MWO 5-9342-1

DEPARTMENT OF THE ARMY MODIFICATION WORK ORDER

MODIFICATION OF SNIPERSCOPE, SET NO. 1, 20,000 VOLTS, ADAPTED TO M2 CARBINE

6 March 1957

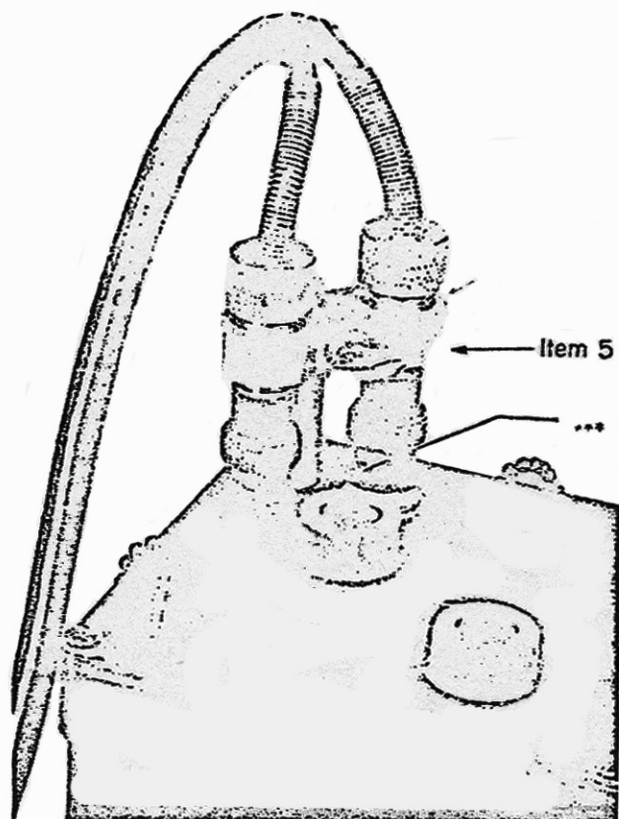
b. Remove the old style eyeshield assembly when it becomes defective, and replace it with a new eyeshield assembly (item 1, fig. 1).

d. Attach lamp socket cover and adjusting eccentric (item 4, fig. 1).

e. Remove reticle housing and replace with modified reticle housing (item 9, fig. 1). This click type changes strike of bullet 6 inches at 125 yds.

o. Remove old cover lamp socket and install new cover (item 10, fig. 1).

Figure 2. Shielded cable grip.

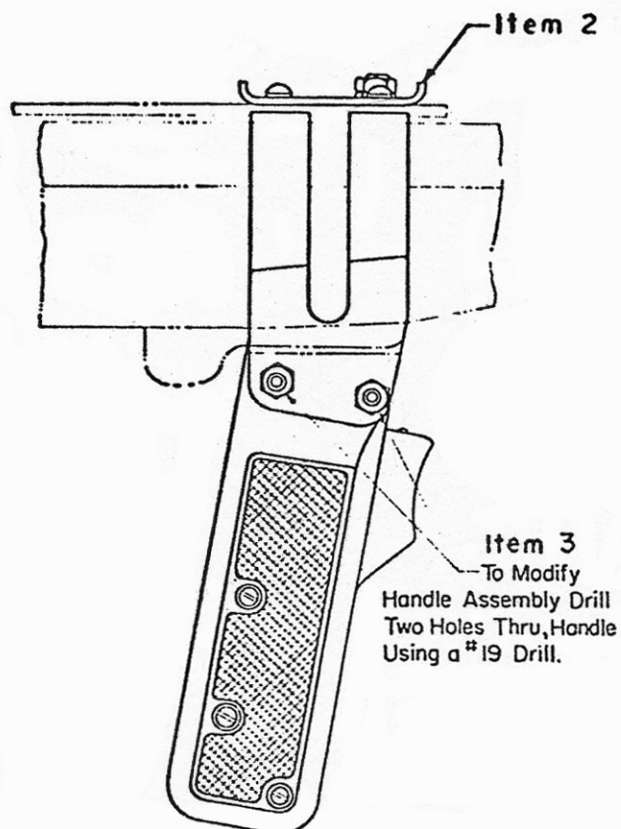
g. Remove the present type cable grip and replace with a shielded cable grip (item 5, fig. 2) and cut off strain cable flush with outside wrap.

Figure 3. Grip switch, bracket assembly.

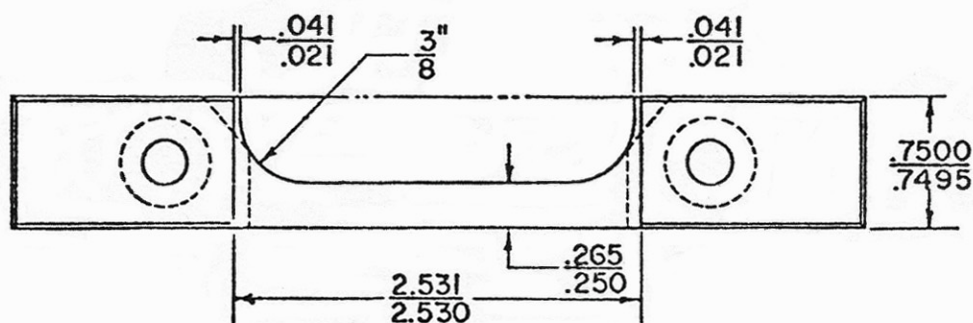
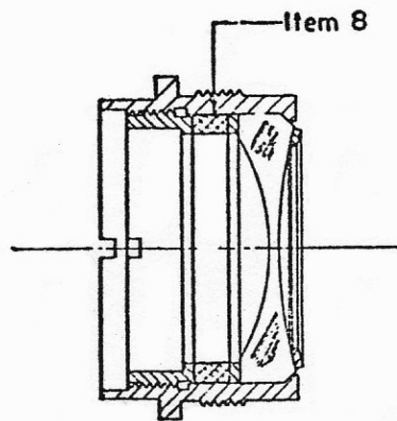
c. Attach a grip switch bracket assembly (item 2) to the carbine (fig. 3). Fasten a modified grip switch (item 3) to the bracket assembly. The present handle assembly can be modified by drilling two holes in the handle as shown in figure 3, using a number 19 drill to clear threads.

Figure 4. Modified mounting bar.

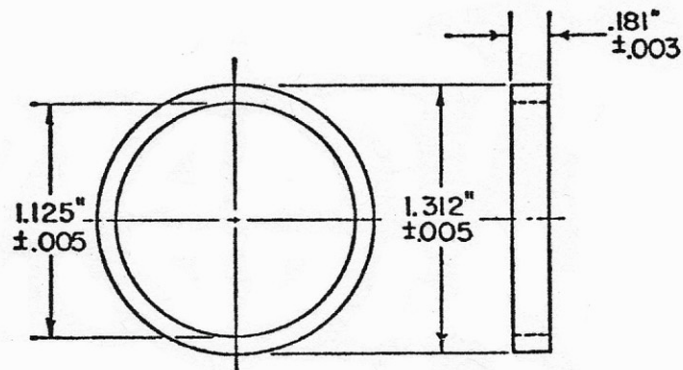
f. Remove the old style telescope mounting bar and replace it with a modified mounting bar (item 6). The old style mounting bar should be modified as shown in figure 4. The modified part should then be returned to stock.
